First of all we sincerely thank the reviewers for their work in reviewing the manuscript. These reviews were helpful to improve the manuscript and we hope that their justified concerns will be answered here. The reviewer's comment is in normal color, while the answer is in blue.

This is a thorough and important study demonstrating how the CloudNet radar network can be leveraged to provide intercalibration between ground-based and spaceborne cloud radars; it expands and improves upon the previous work by Protat et al. and Kollias et al using similar methods, and will provide an important means of monitoring and calibrating ground-based radars and EarthCARE during its lifetime. The manuscript is well-structured and clearly written, and the figures are well-presented; however, there are some methodological issues which need addressing to make the treatment of EarthCARE data consistent with the ground-based and CloudSat data. I recommend this paper for publication subject to major revisions.

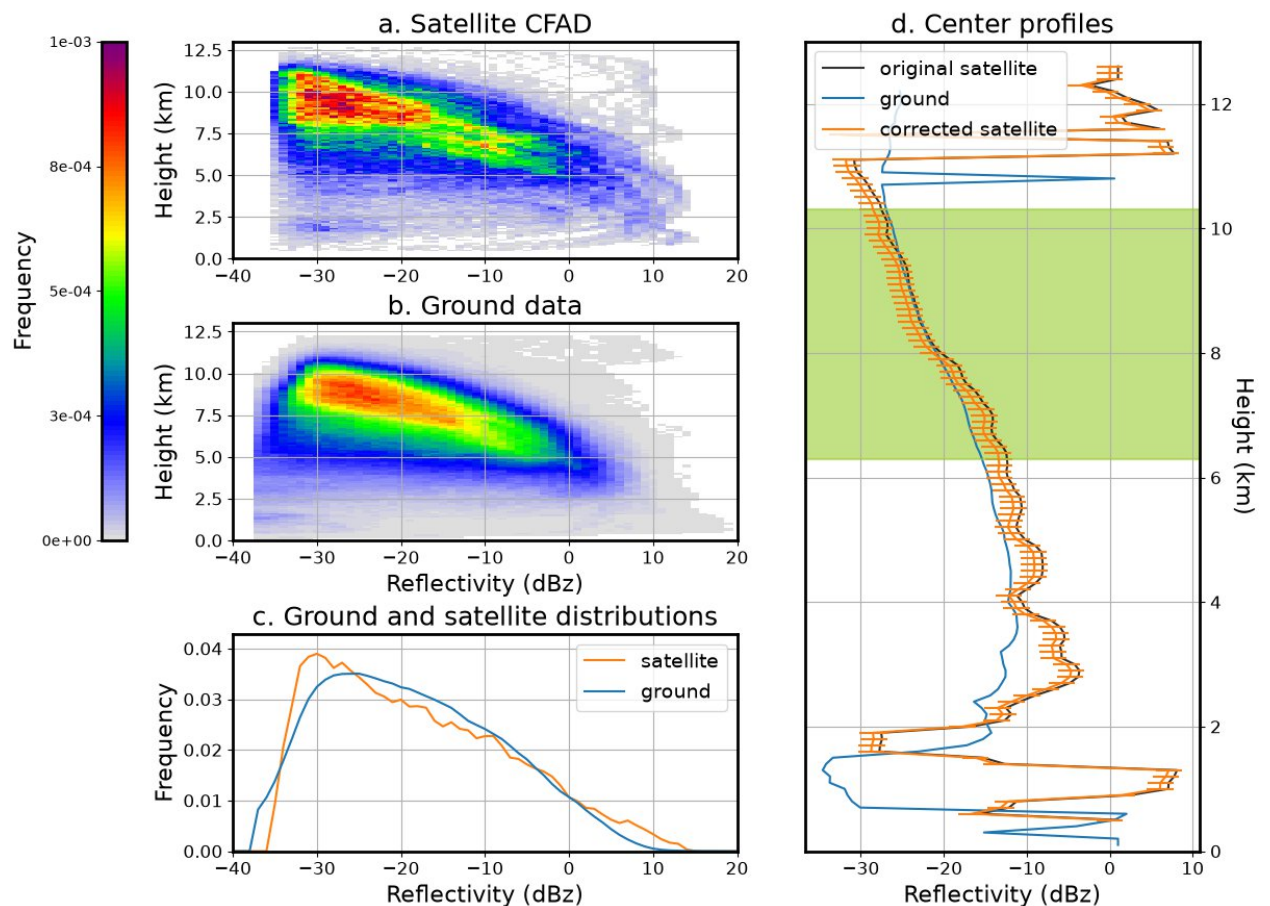
1. For the selection of ice clouds from the ground-based and CloudSat datasets, the CloudNet and DARDAR-MASK target classification products are used to identify liquid cloud layers. Both of these products are synergistic radar-lidar target classifications, wherein the lidar provides the bulk of the detections of liquid cloud. For the current analysis of EarthCARE CPR data, however, it appears that the CPR L2a product (C-TC) is being used. While C-TC contains a classification of liquid cloud (alongside many detections of rain and melting layers, as described in Section 4.3), it will miss the vast majority of non-precipitating liquid cloud—and especially supercooled liquid cloud. This was shown in Irbah et al. (2023). In fact, the C-TC product is not capable of diagnosing supercooled liquid at all: all hydrometeors detected at temperatures below the freezing level will be classed as ice or snow. It may be that the existing criteria for selection of data are screening these cases out to some extent, but there's a good chance that mixed-phase clouds are not entirely removed from the EarthCARE data at present.

We understand this concern as it was also one of ours during this study. The AC-TC classification was not used for several reasons. The first one being known issues in the classification for the BA baseline. An issue corrected in BC baseline was the misclassification of liquid clouds to aerosols (<https://earth.esa.int/eogateway/documents/d/earthcare-data-handbook/earthcare-ac-tc-level-2b-processor-disclaimer>). We therefore prioritize the removal of liquid clouds over the attenuation from supercooled water. Looking at our final closure, this tradeoff does not seem detrimental as we have a very good agreement between EarthCARE and the ground stations.

Another concern we have is that as supercooled water is detected through the lidar, the geometry of the observation could be a problem. As EarthCARE observes from the top of the cloud, a supercooled water layer embedded in the cloud could be invisible if the lidar is attenuated before it. The same inverted phenomena could happen from the ground. An instrument seeing supercooled water could therefore lead to not removing it for the other, thus keeping an observation of a cloud in the dataset that is not in the other. This would need to be investigated if we want to precisely filter the profiles with supercooled water.

Figure R1 is the equivalent of figure B1 from the manuscript, with supercooled water filtered using AC-TC for the satellite and CloudNet classification for the ground. Removing the supercooled water with AC-TC divides by 2 the number of available satellite profiles and the inferred bias is larger. Taking account of the uncertainties, the results with and without

supercooled water are coherent one with another. Looking at R1, we also see that between 8 and 10 km, the ground and satellite center profiles are similar, but this similarity fades at heights lower than 8km.

To summarize, the removal of supercooled water should be possible and could be beneficial when the classifications products have undergone more validation. We think that this filtering would need further investigations and should be done carefully. For our methodology, this could also require to refine our height selection parameters.

Changes to the manuscript: Added a discussion on why we did not used AC-TC, lines 128-130. Added a discussion on the future use of the AC-TC product to filter supercooled water, lines 474-476 .

Figure R1: Frequency of day and night overpasses for the site of Juelich on the period from 2024-07-20 to the 2025-11-18.

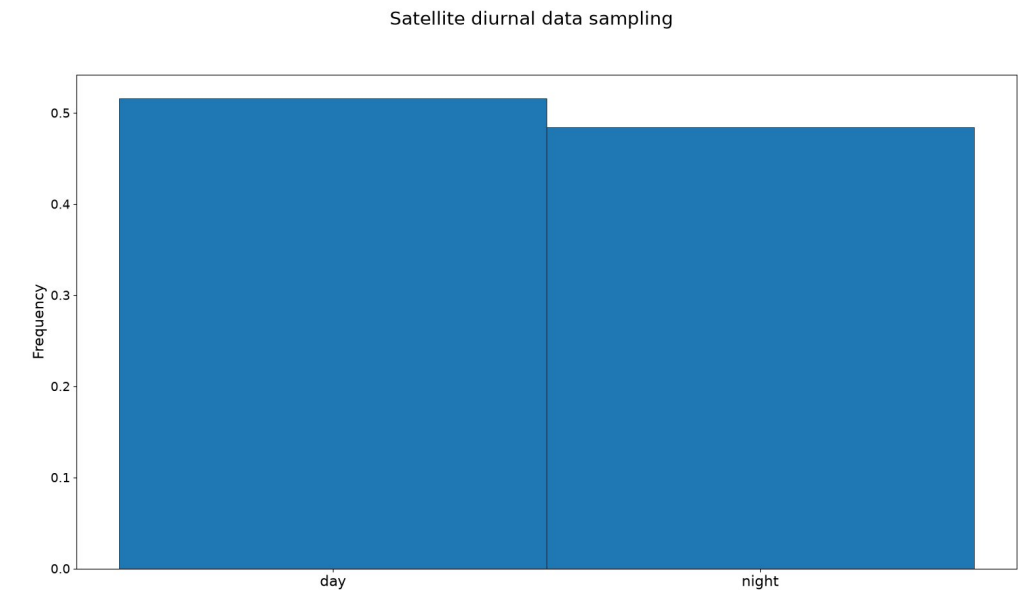
1. Instead of introducing a fixed time-window around overpass time, they just used all of the ground-based radar data obtained during the comparison period of 15 months. This implies that CPR detected clouds are different from ground-based radar detected clouds. However, there is an assumption that CPR detected many clouds within 200km around an ACTRIS site contain the same ensemble of clouds detected by ground-based radar in the site although different time is chosen. The assumption is not clearly written/defined and justification of ignoring the time issue might be insufficient, e.g., diurnal variations of cloud structure and nature might occur. Some discussion of this point might be given. If they will add above mentioned points and related discussions, the manuscript will be hopefully improved.

This concern was also one we had during this study. Concerning the diurnal variations of the cloud structures, all the sites used in this study have day and night overpasses of the same order. Figure R1 shows an example of the contribution from both day and night overpasses for one of our site. We see that day and night overpasses have an equivalent contribution, this is also observed for the other sites of our study.

The decision to use all of the ground data instead of only data in a ± 1 h window around the overpass comes from the observation that in the majority of cases, the ground and satellite observe different clouds. On the 183 overpasses in the 15 months considered, less than 20 show similar clouds, hence why a long statistical comparison is needed. Single overpasses figures for a site will be added in supplementary material to show this. Limiting the collection of ground data in a ± 1 h window drastically lower the number of profiles from the ground, as shown in appendix A. We therefore consider that evaluating the bias at the most statistically similar height bins leads to comparing similar clouds observed by both the ground and satellite. The weight of eventual outlayer data introduced by considering all the ground profiles should also be reduced by the fact that we consider the center of the fit to evaluate the bias, thus reducing the weight of outlayer data. As we see from Appendix A, considering a ± 1 h window or the whole ground data leads to similar bias results with our methodology. This leads us to think that with enough time, both ground data selection methods should converge to the same bias result.

Changes to the manuscript: As the discussion on this is in Appendix A, it was modified to improve its relevance. Supplementary material with figures from all the overpasses for the site of Juelich will be added.
